ADDENDUM NUMBER TWO

**HCPS WAREHOUSE BUILDING
HENDERSON COUNTY/HENDERSON COUNTY PUBLIC SCHOOLS**

MLA PROJECT NUMBER: 21010

DATE OF ISSUE: August 25, 2021

**WALL
 SECTIONS
 & ALT 1**

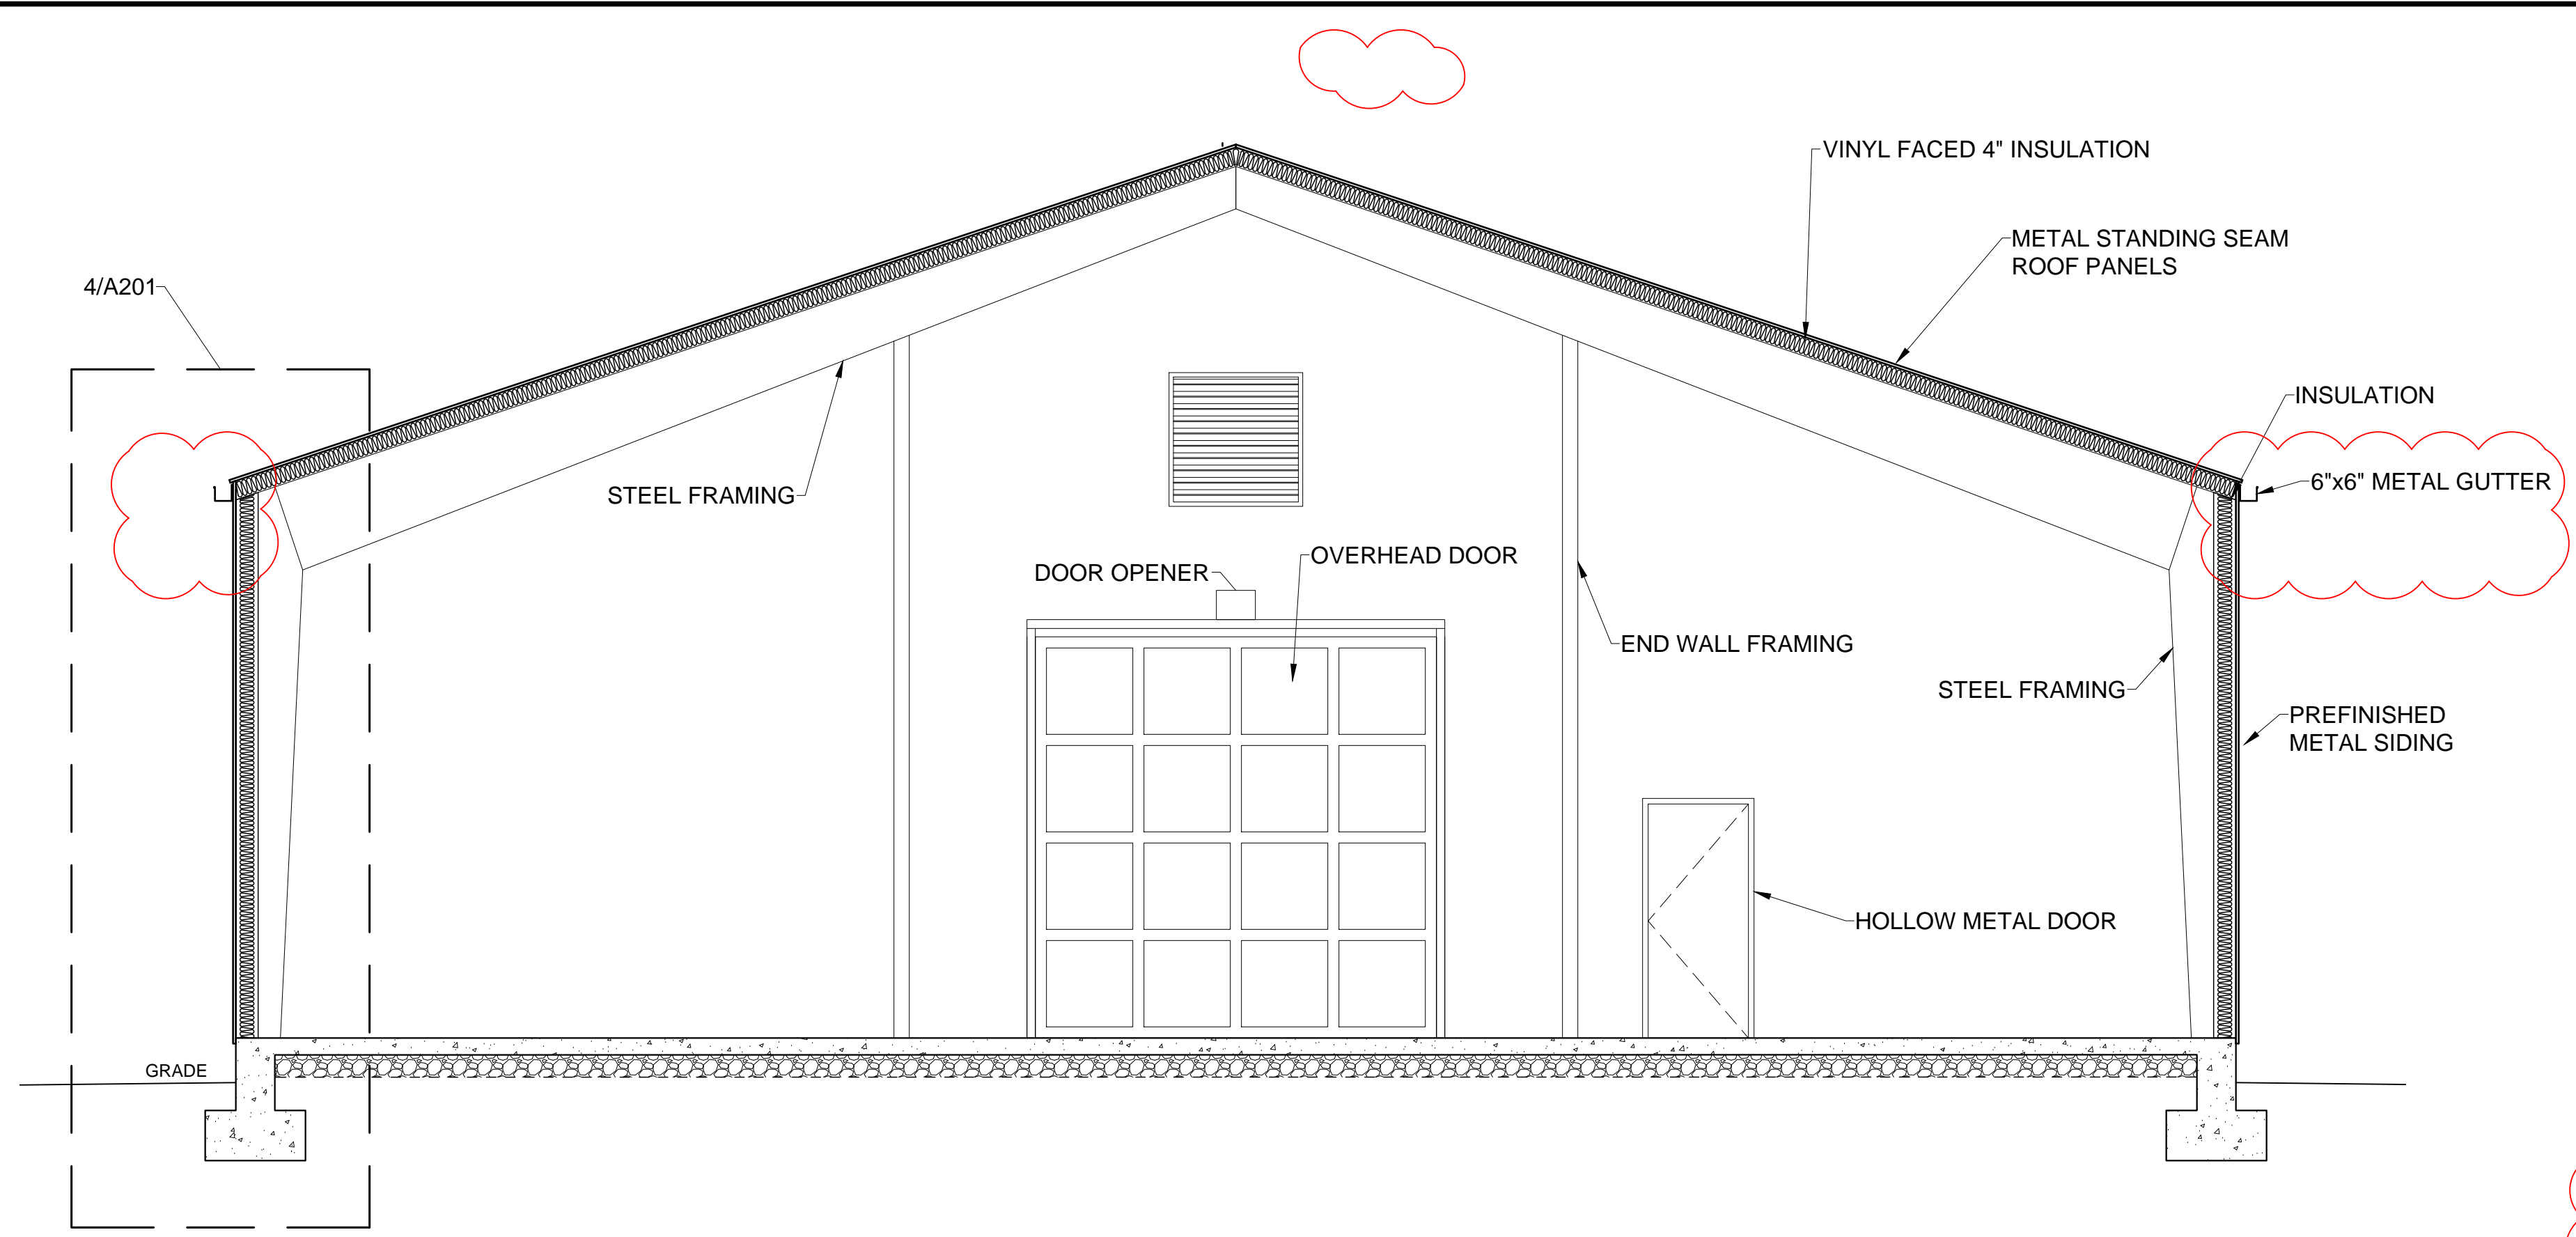
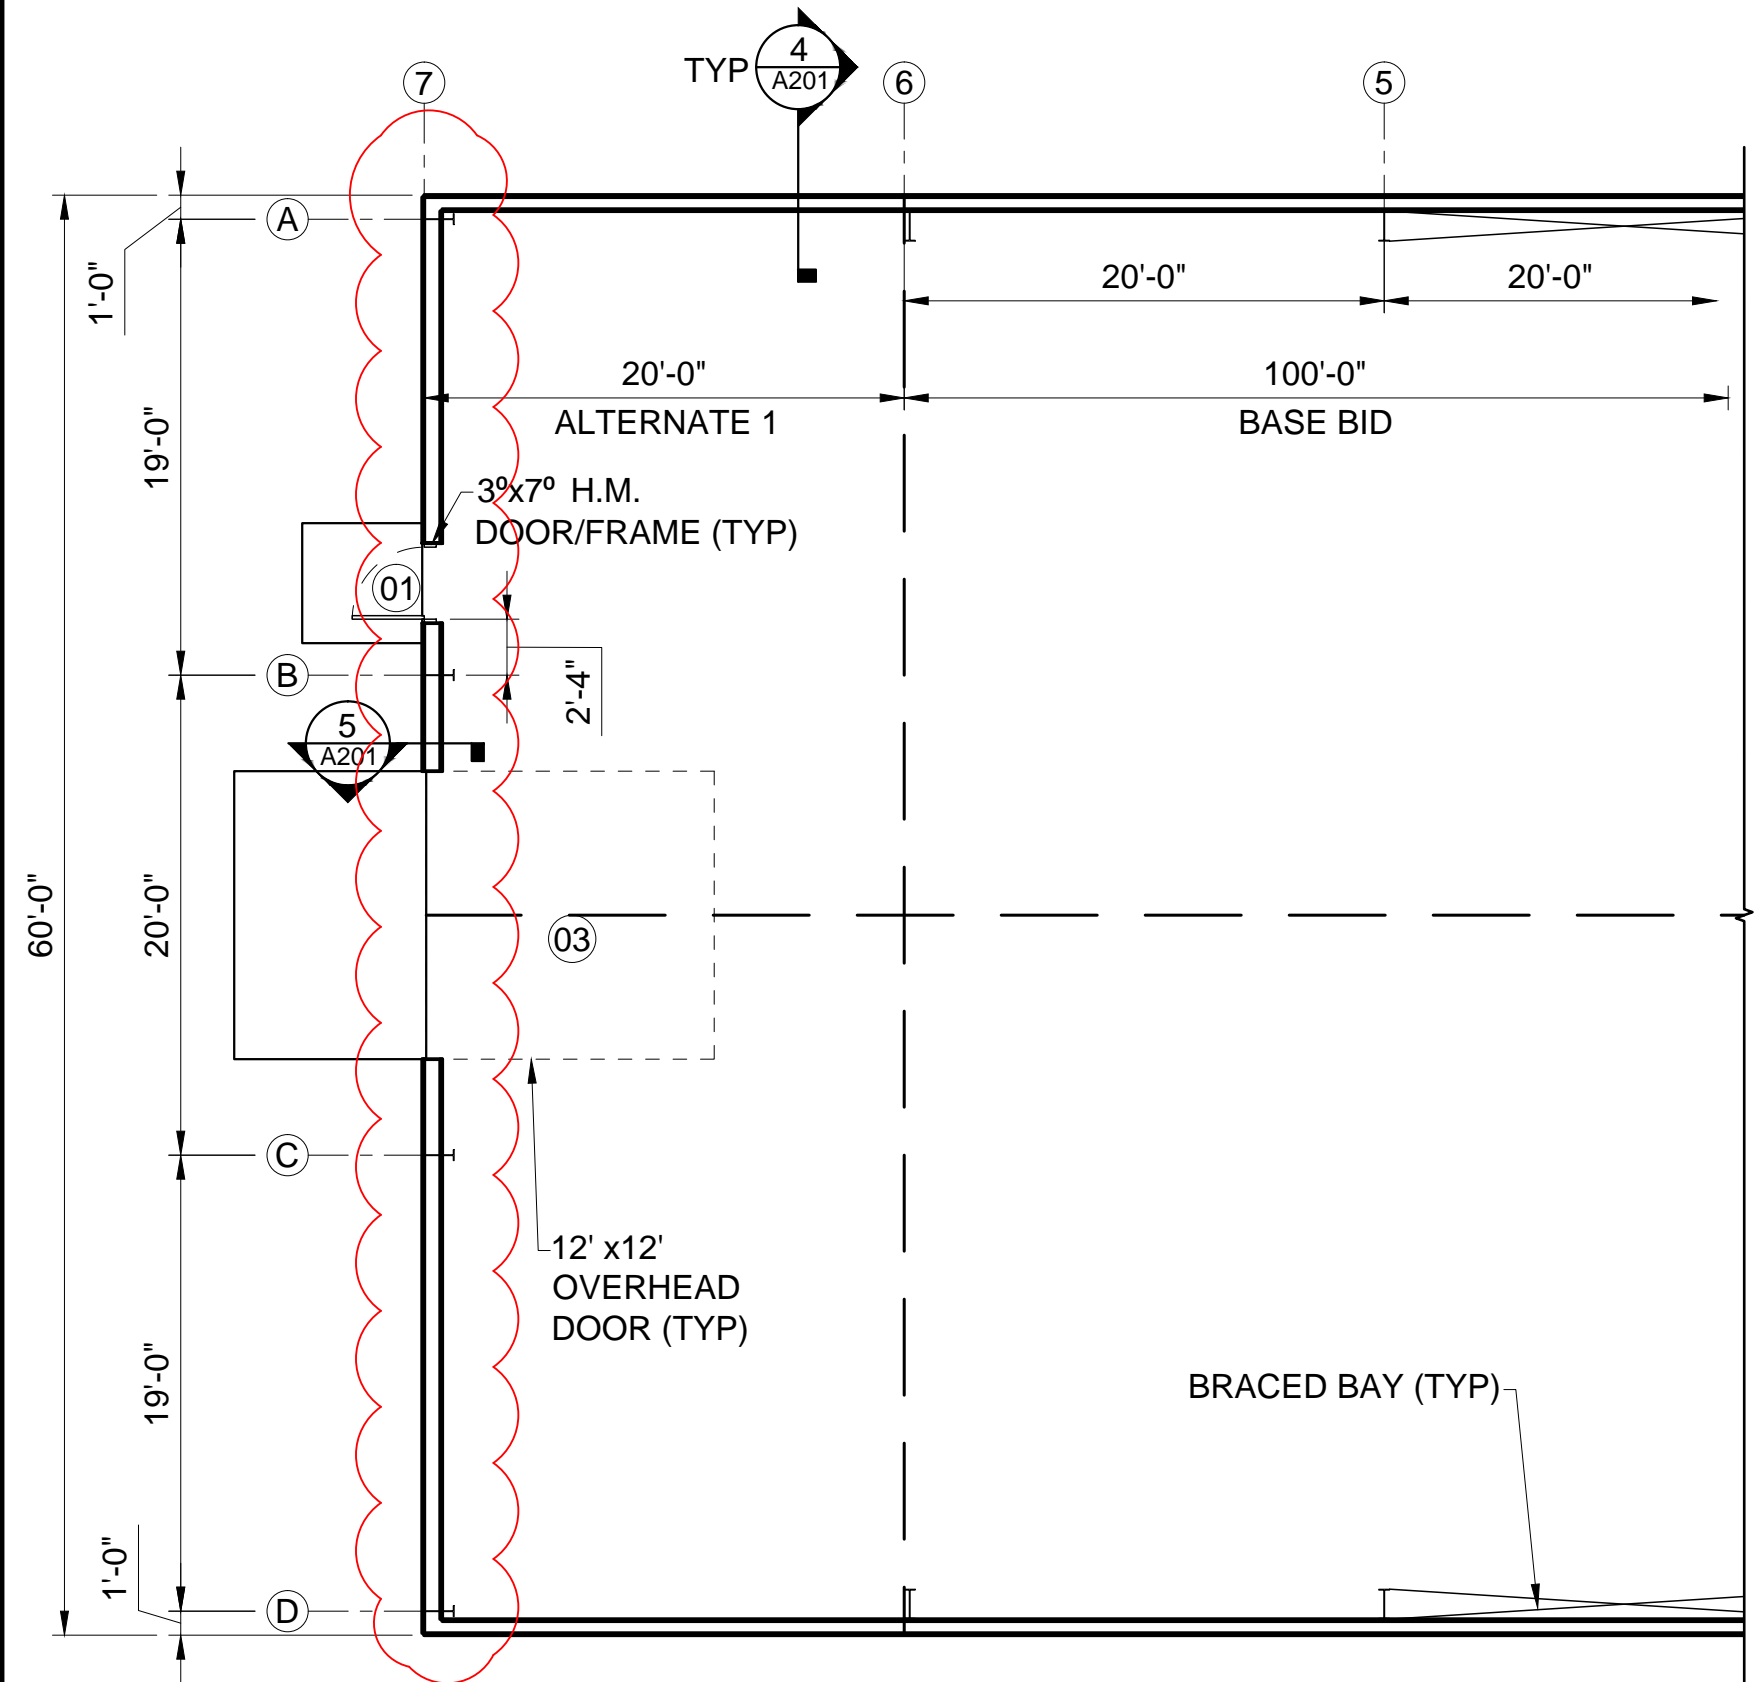
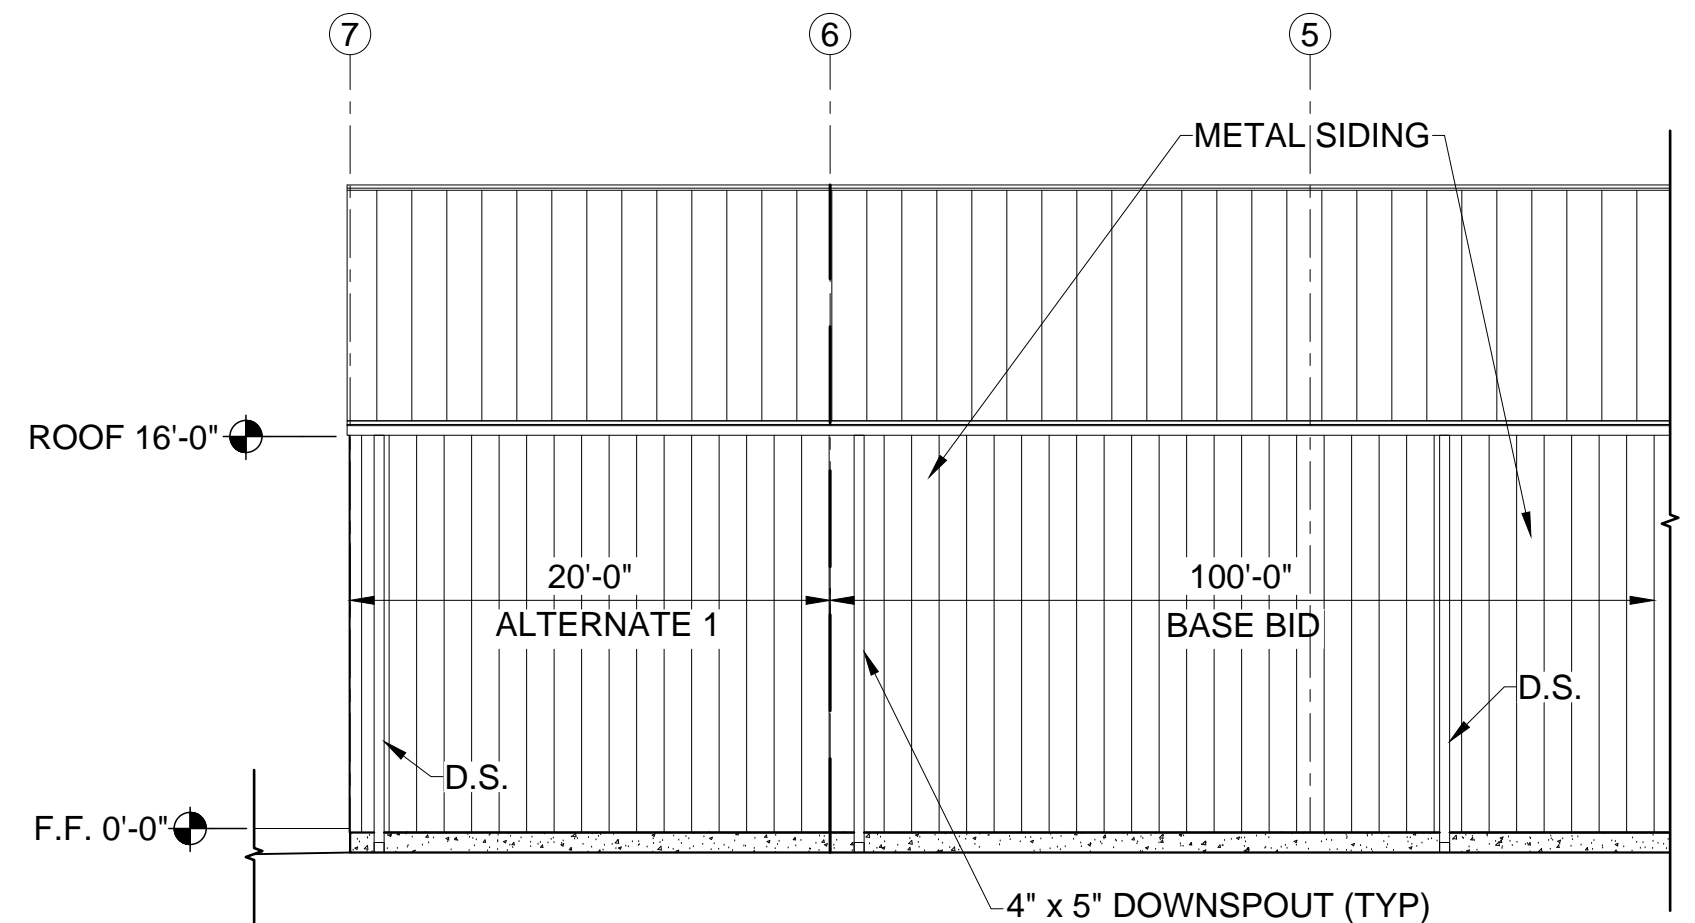
- Top soil removed for clearing is acceptable for outside fill
 - Exterior concrete clarifications and note
2. A101/ A201:
 - The soffit is deleted from the building
 - The ridge vent is deleted from the building
 - The passage door location is corrected on Alternate 1 plan
 - Concrete floor stone base thickness changed to 4"
 3. 4-5/A201: revise 6 mil VB to 10 mil VB
 4. E1/E2/ E3/ E4:
 - An exhaust fan is added to the south louvers and specified on Lighting Fixture Schedule
 - The passage door locations are corrected on Alternate 1 plan
 - The meter box and panel are re-located to the south corner wall
 - Panel A is revised to include EF's
